STAFF RECOMMENDATION
1610 Sumner Avenue
December 21, 2016

Application: Demolition; New construction—detached accessory dwelling unit
District: Eastwood Neighborhood Conservation Zoning Overlay
Council District: 06
Map and Parcel Number: 08306006900
Applicant: Barbara Harper, Owner
Project Lead: Sean Alexander, sean.alexander@nashville.gov

Description of Project: Application is to construct a detached accessory dwelling unit (DADU) at the rear of the lot.

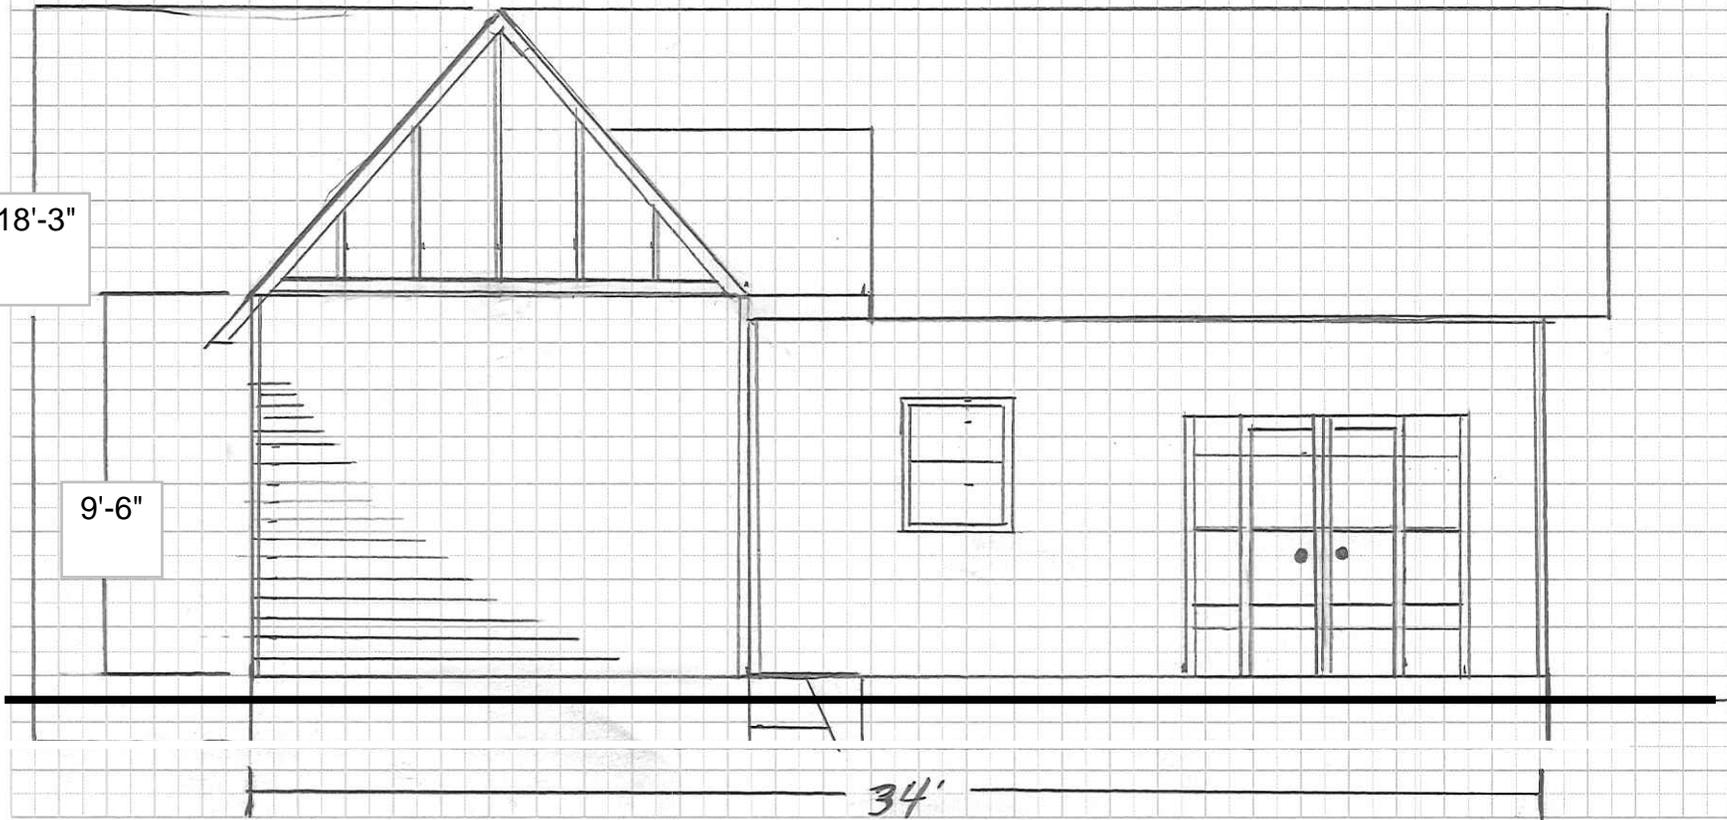
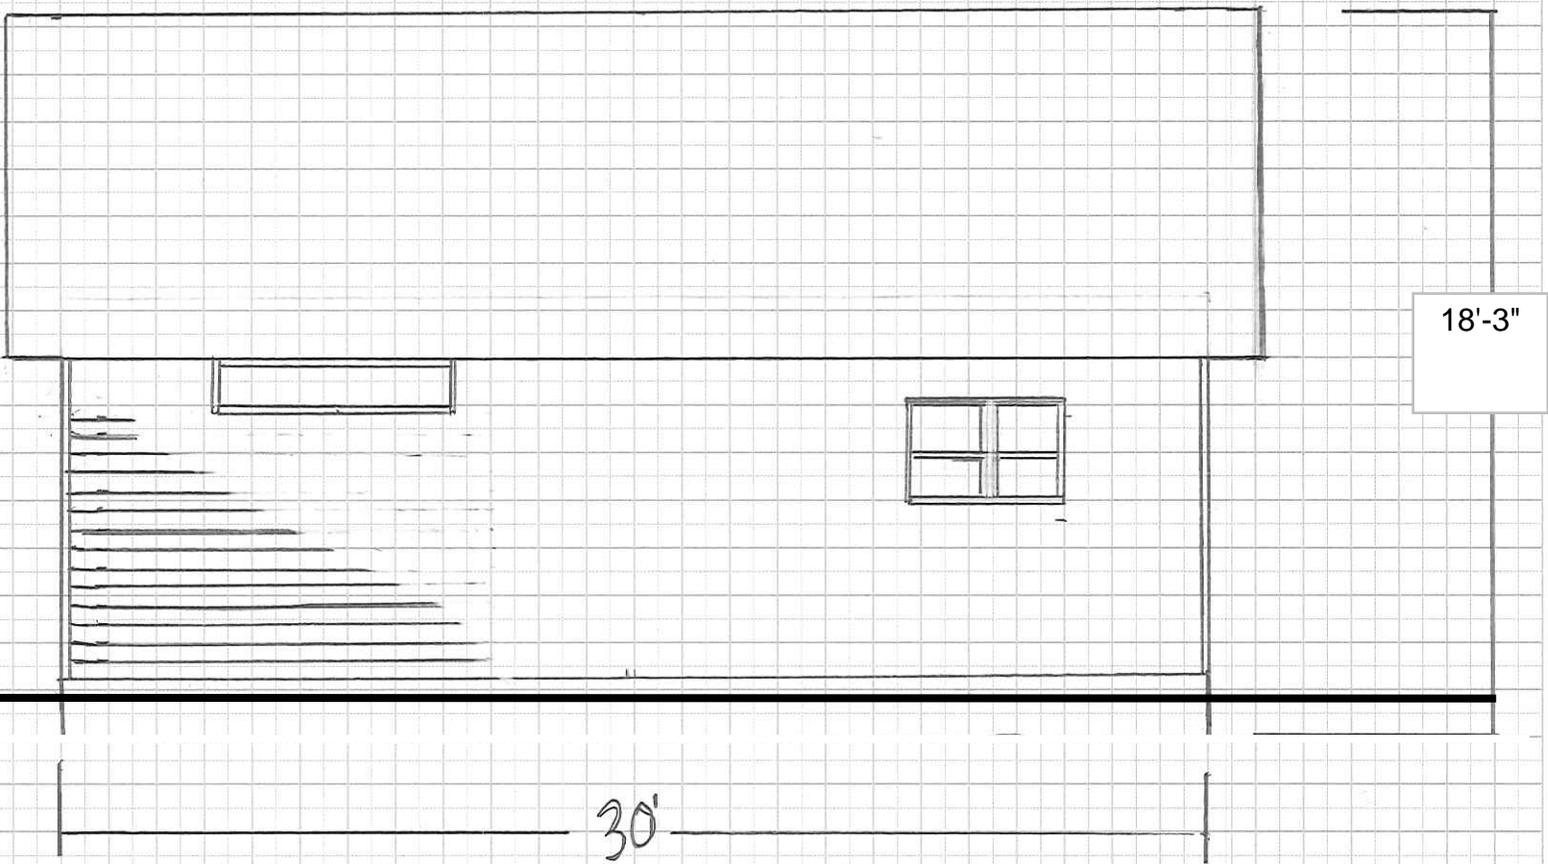
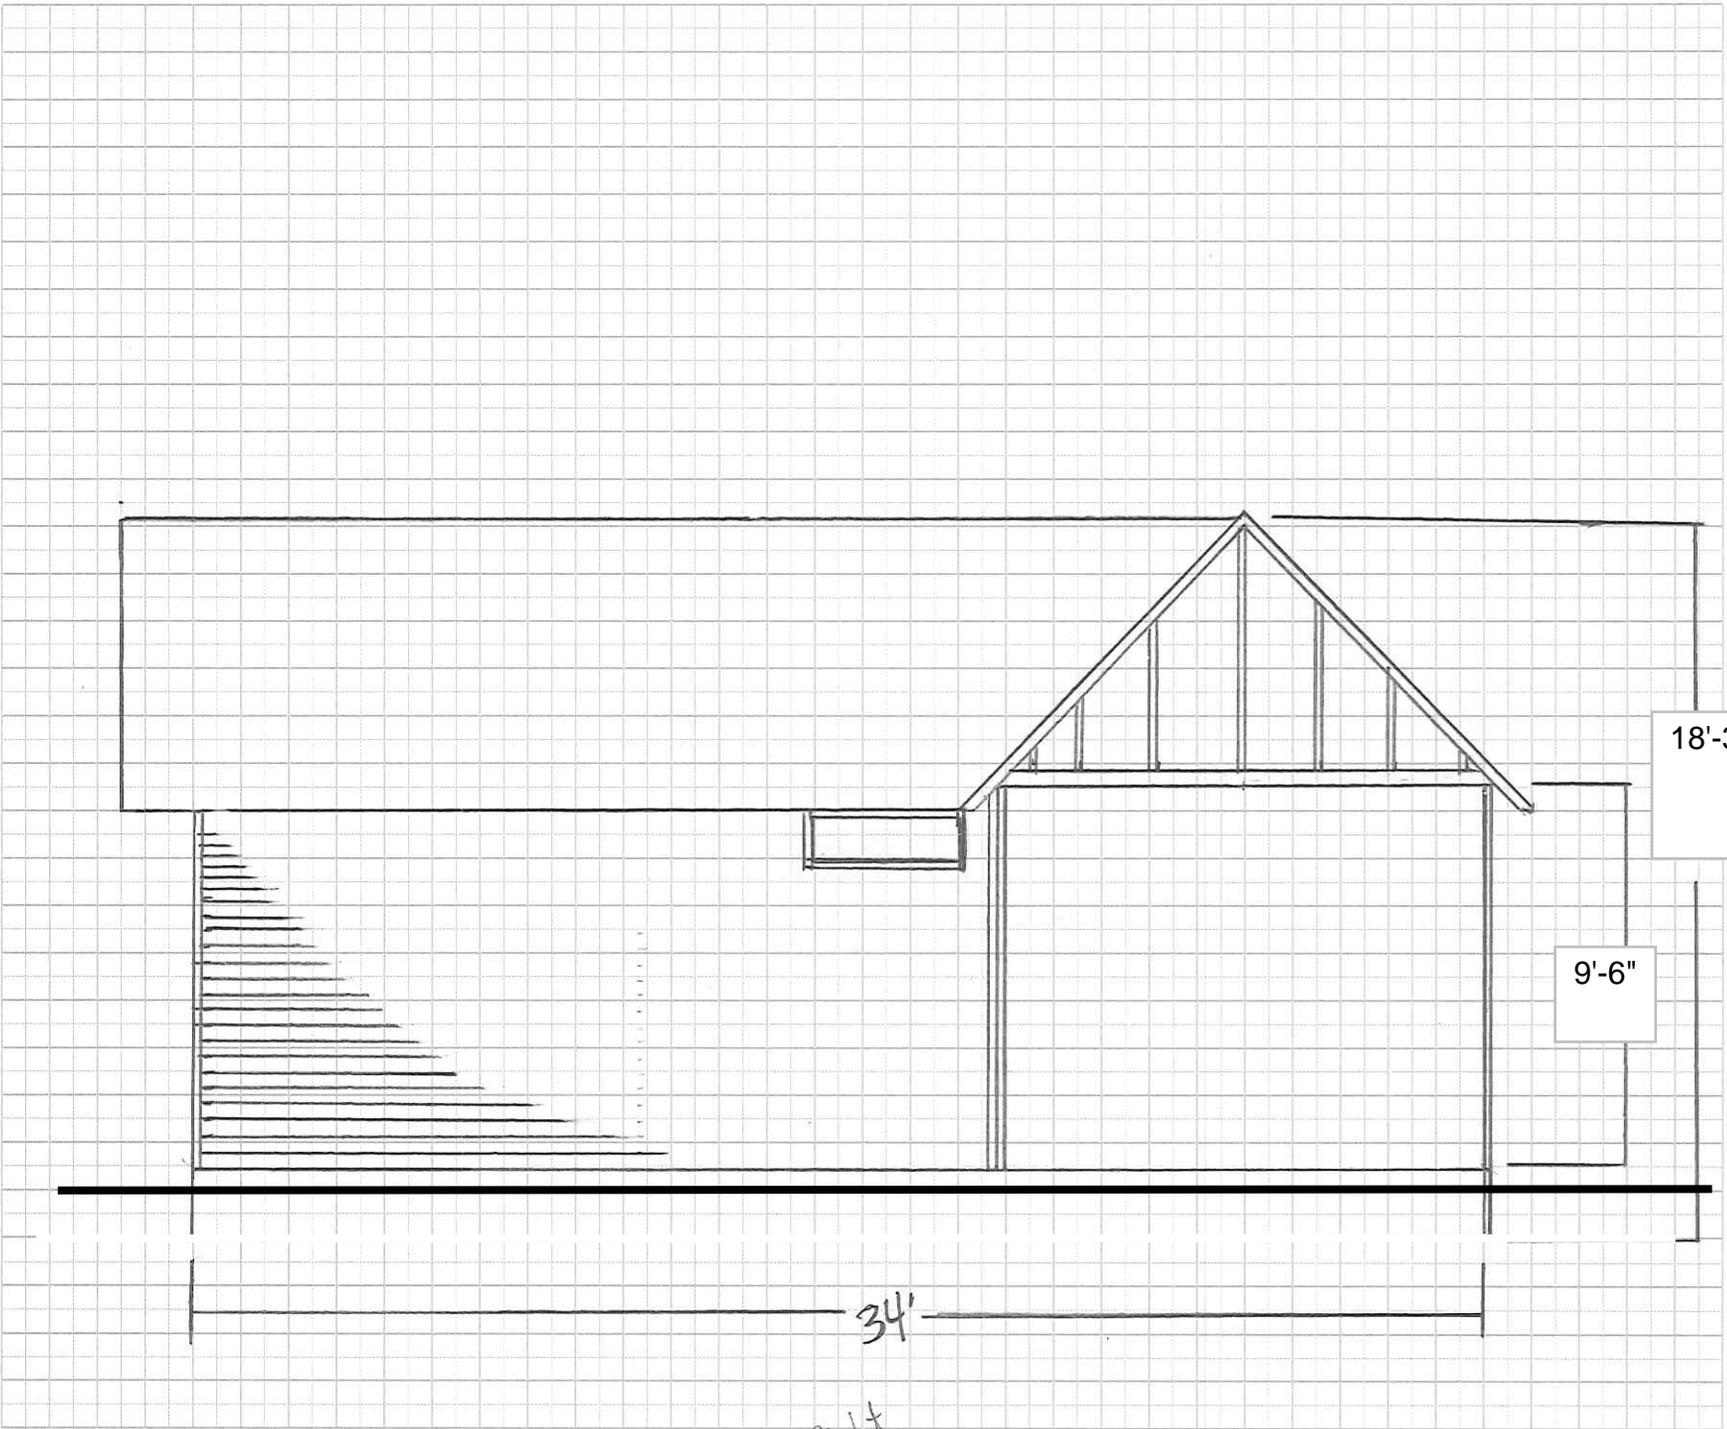
Design Standards: The accessory structure has a simple, utilitarian design that is appropriate for outbuildings. Its roof form and pitch will be typical of historic outbuildings in the area and will not contrast greatly with the primary structure. The fenestration is minimal, but not uncharacteristic for an outbuilding. It is also in a minimally-visible location behind the principal

Proposed Element	Proposed Form	Typical of district?
Primary form	Cross-gable	X
Primary roof slope	12:12	X
Porch roof form	Front-gable	X
Porch slope	8:12	X

Because the roofs are to those of historic outbuildings, the project meets Section II.B.1.h.1 of the design guidelines and section 17.16.030.G.8 of the ordinance.

Proposed	Color/Texture	Approved Previously or Typical of Neighborhood
Foundation	Concrete slab	Natural color	X
1st Story Cladding	5" cement-fiber clapboard	Smooth	X
2nd Story Cladding	Cement-fiber board and batten	Smooth	X
Trim	Cement-fiber	Smooth	X
Roofing	Asphalt shingle	Matching house	X
Driveway	Existing, no change	n/a	n/a
Windows	Not indicated	Needs final approval	X
Pedestrian Doors	Not indicated	Needs final approval	X

With the staff's final approval of the windows and doors and material information that has not yet been provided, staff finds that the known materials meet Section II.B.1.h.1 of the design guidelines.

1. Staff shall approve the final window and door selections prior to purchase and installation; and,
2. A restrictive covenant for the detached accessory dwelling unit shall be filed prior to issuance of a permit.
